VTM COMPLIANCE EXHIBITS
 TITLE PAGE
 MIRAMONTE
 SOLEDAD, CALIFORNIA
 APRIL, 2021

VTM COMPLIANCE EXHIBITS
KEY MAP
MIRAMONTE
SOLEDAD, CALIFORNIA
APRIL, 2021

VTM COMPLIANCE EXHIBITS
AREA 12
MIRAMONTE
SOLEDAD, CALIFORNIA
APRIL, 2021

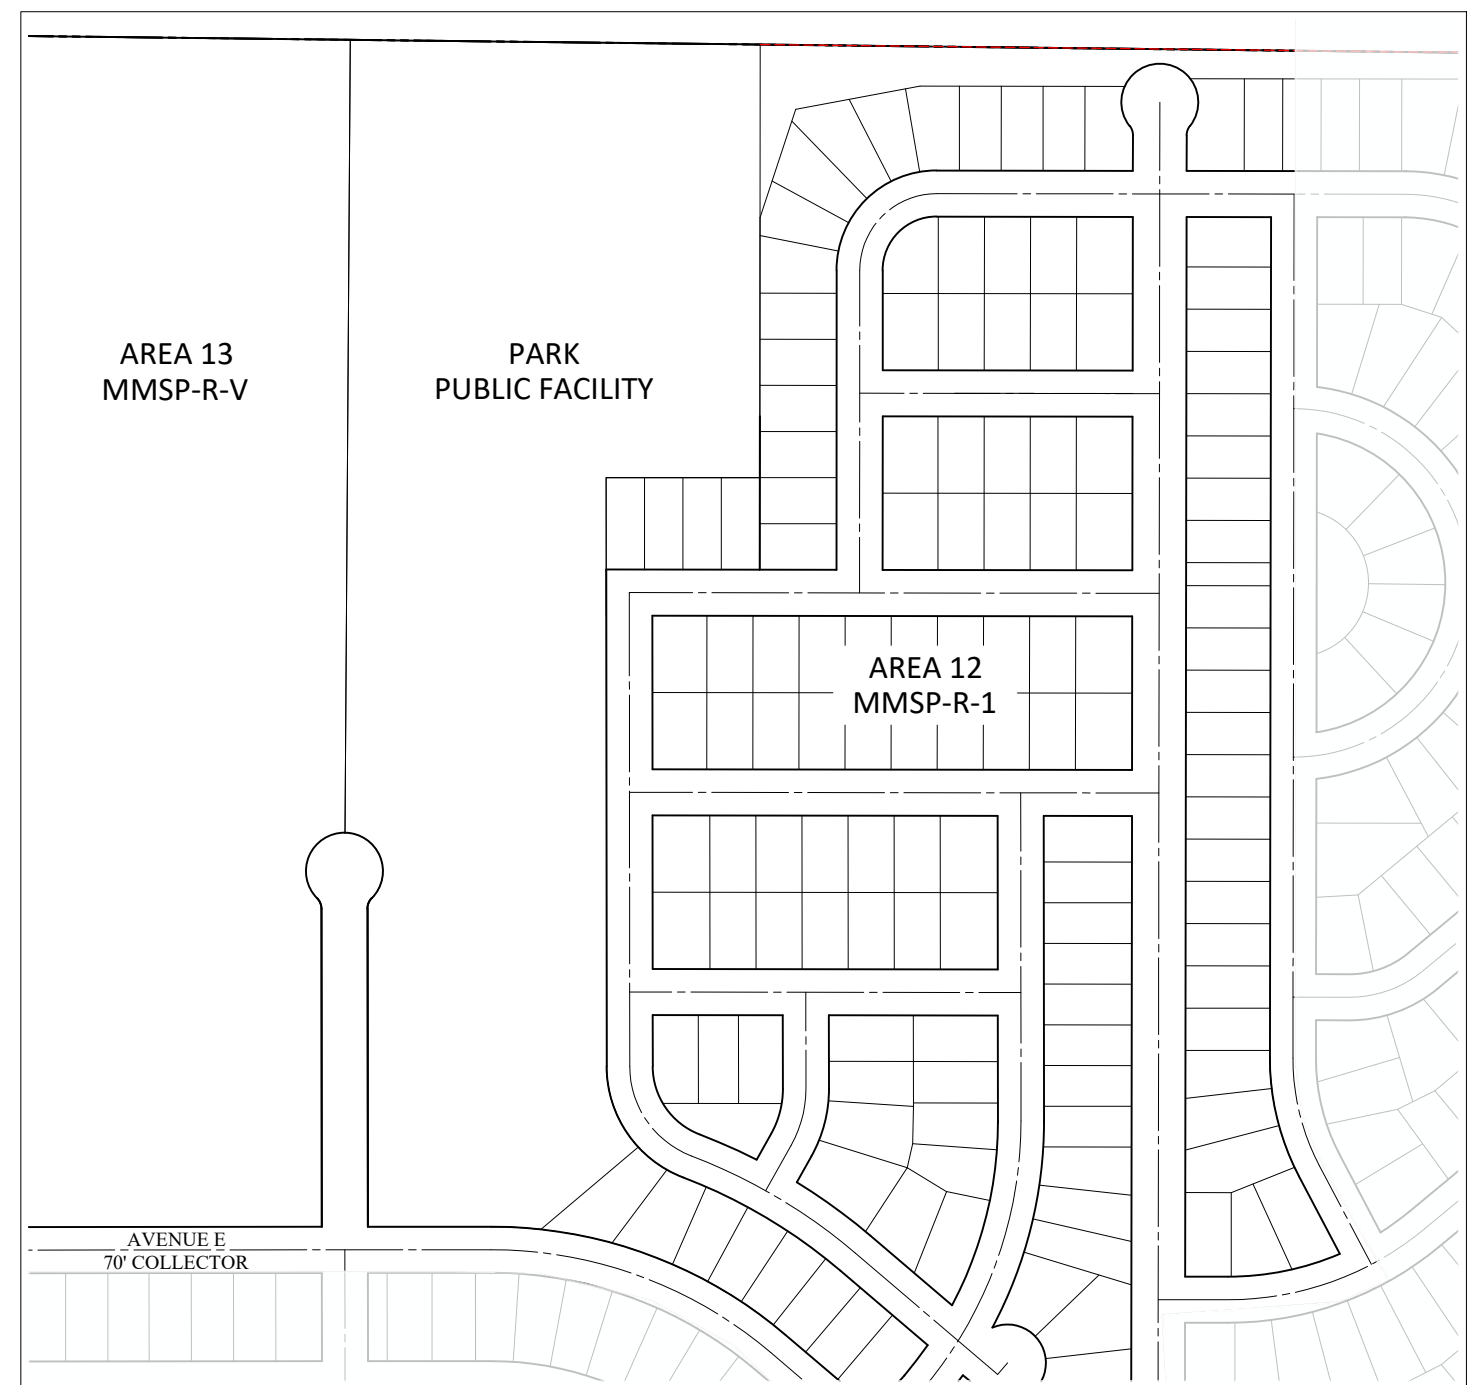
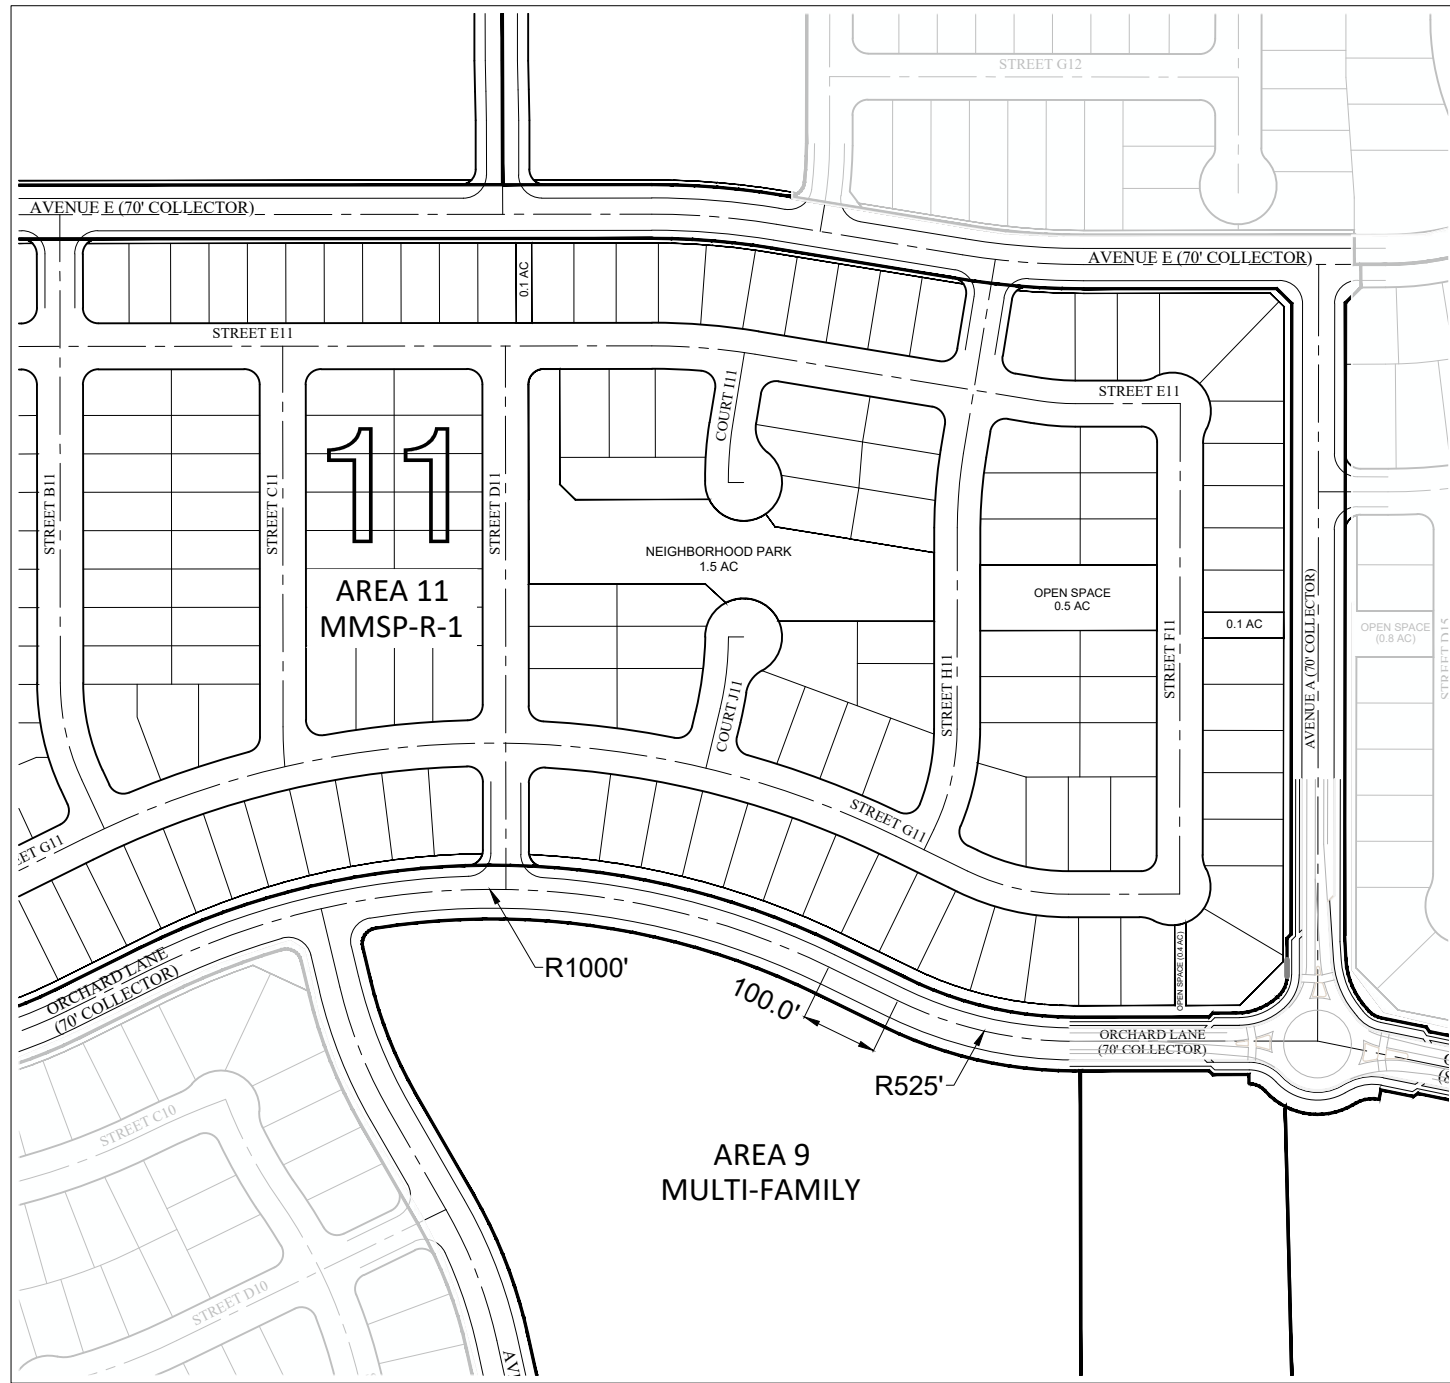
1. STREET AND LOT LAYOUT REVISIONS IMPROVED STREET FRONTAGE ACCESS TO THE SPORTS PARK
2. NO LOTS BACK ONTO THE SPORTS PARK IN THE PROPOSED PLAN
3. INCREASED THE CENTERLINE RADII OF AVENUE E FOR REASONABLE DESIGN SPEED
4. OPEN SPACE ADDED ALONG AVENUE E TO ACCOMMODATE GRADE CHANGES AND PUE AREA

AREA 11

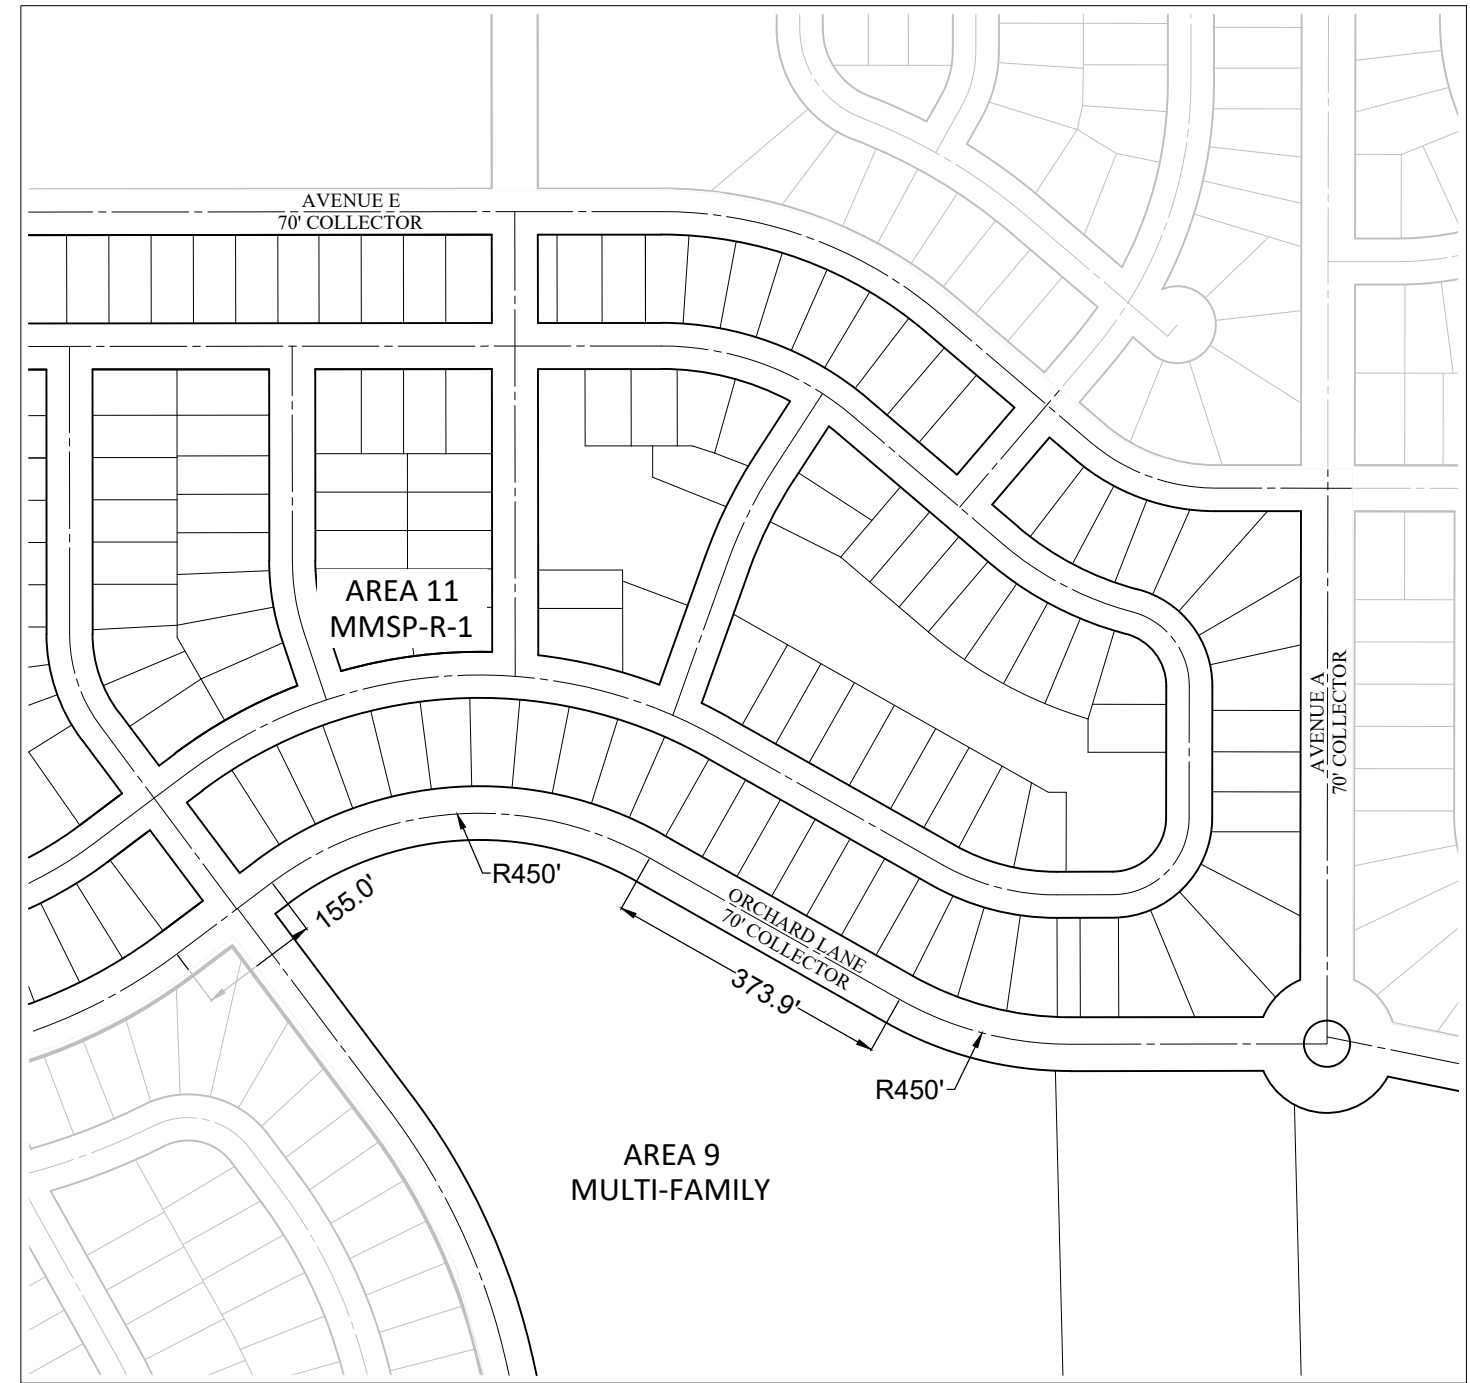
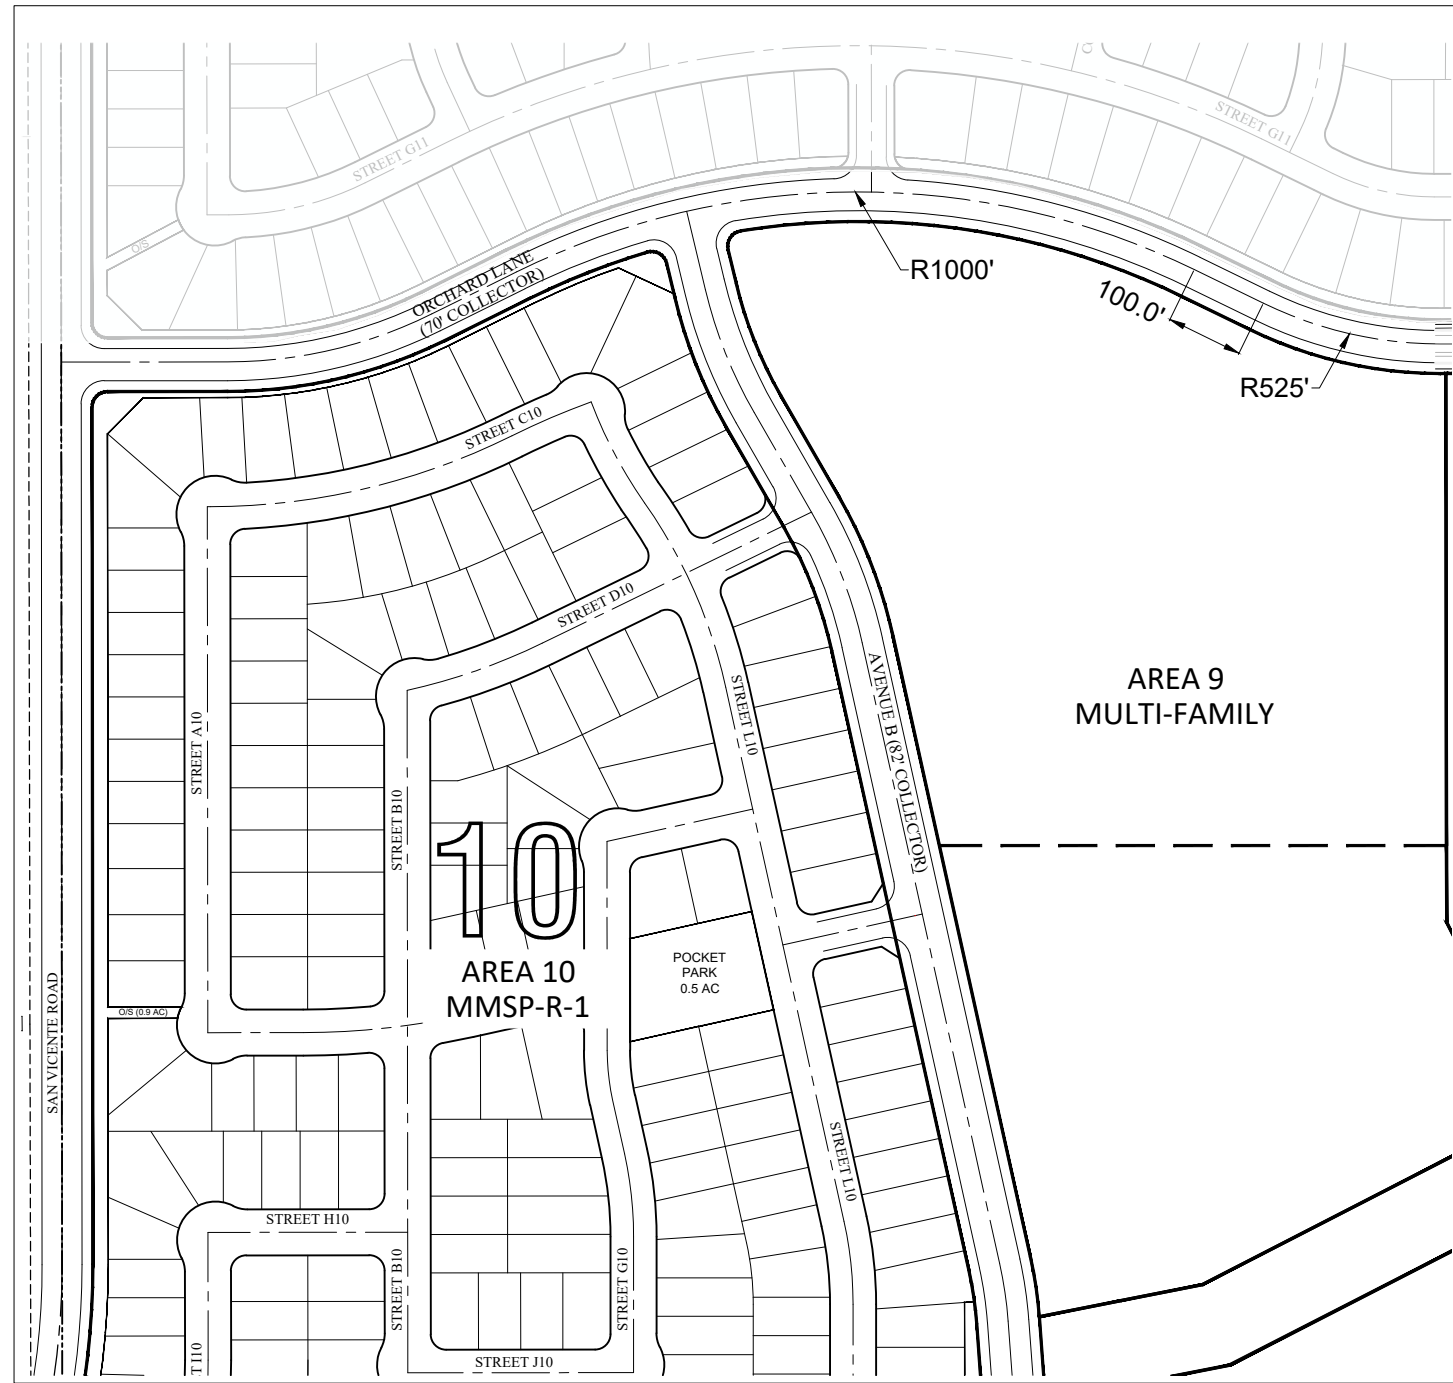
1. STREET AND LOT LAYOUT REVISIONS ELIMINATED BACK-ON LOTS ALONG THE NEIGHBORHOOD PARK
2. OPEN SPACE TRAIL ADDED TO CONNECT THE NEIGHBORHOOD TO THE SCHOOL WITH AN ENHANCE PEDESTRIAN CROSSING
3. OPEN SPACE ADDED ALONG ORCHARD LANE TO ACCOMMODATE GRADE CHANGES AND PUE AREA
4. INCREASED THE CENTERLINE RADII OF ORCHARD LANE FOR REASONABLE DESIGN SPEED
5. INCREASED THE ROW FOR ORCHARD LANE TO ACCOMMODATE THE TWO-WAY LEFT-TURN LANE RECOMMENDED BY THE CITY'S TRAFFIC CONSULTANT

MIRAMONTE HILLSIDE OPEN SPACE AREA CALCULATIONS

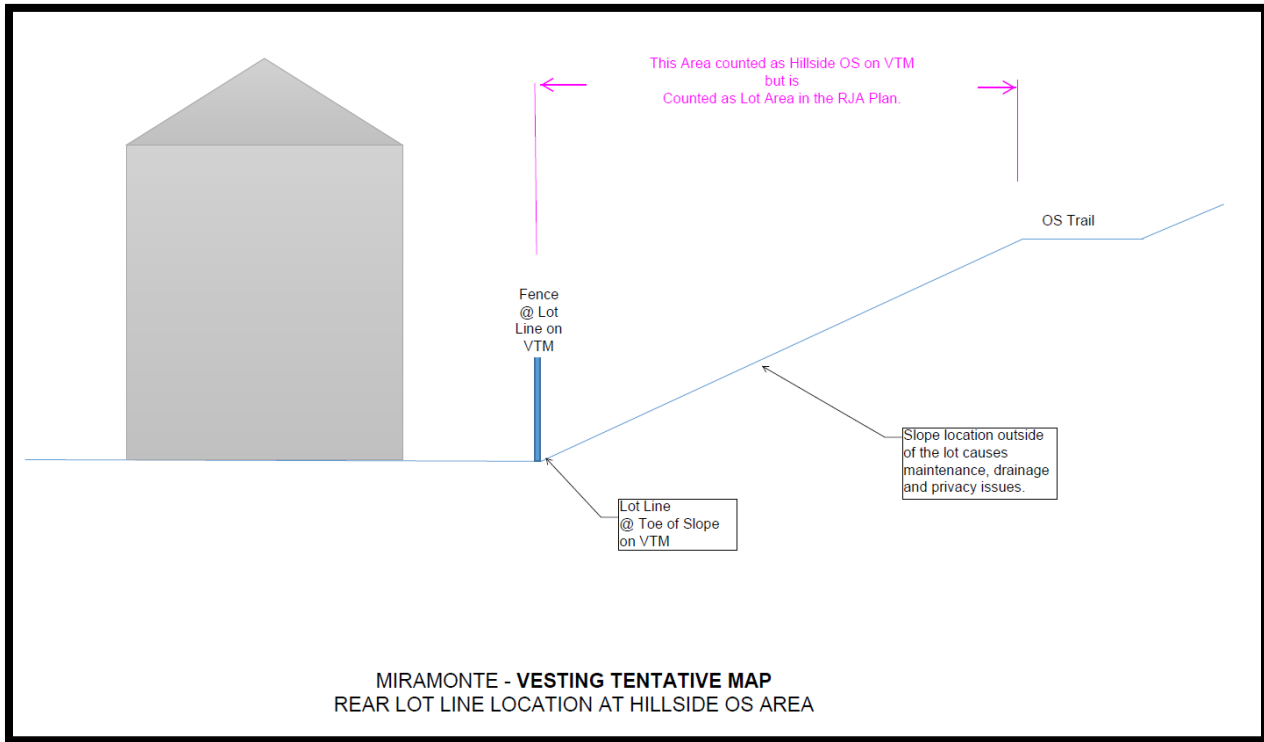
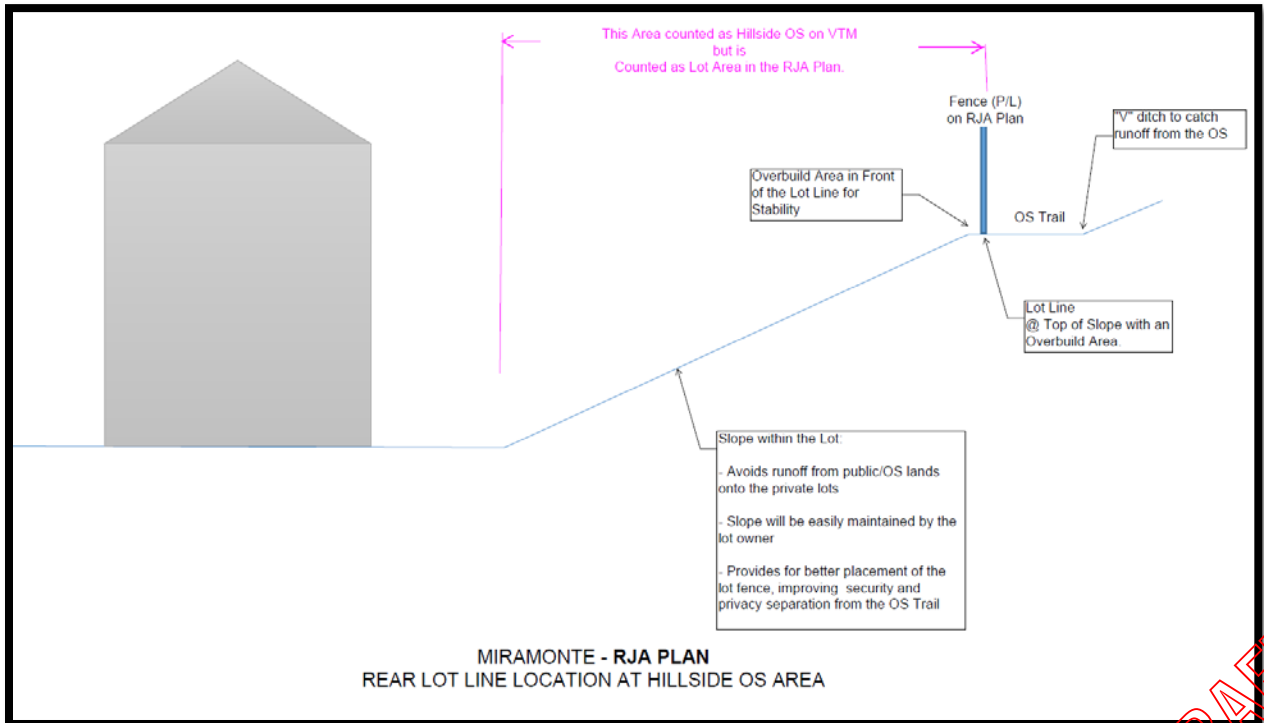
The Hillside Open Space land area differs between the Vesting Tentative Map (VTM) and the current Land Plan, mainly due to the placement of conforming slopes behind the single-family lots that back onto the hillside open space parcel.

The land area of the conform slopes equals approximately 6.7 acres. **Figure 1** depicts the relationship between the private lot line/fence, the conforming slope, and the hillside open space parcel, given the lot layout on the VTM. **Figure 2** shows a more typical relationship of these elements as is proposed for the current plan. Locating the conforming slope within the private lots is typical and advised for the following reasons:

- To avoid runoff from the public/OS lands entering onto the private lots.
- To provide clear maintenance responsibilities.
- To avoid inaccessible slope areas that cannot be reasonably maintained without maintenance personnel entering private property.
- To place the rear lot fences at the level of the trail, improving security.
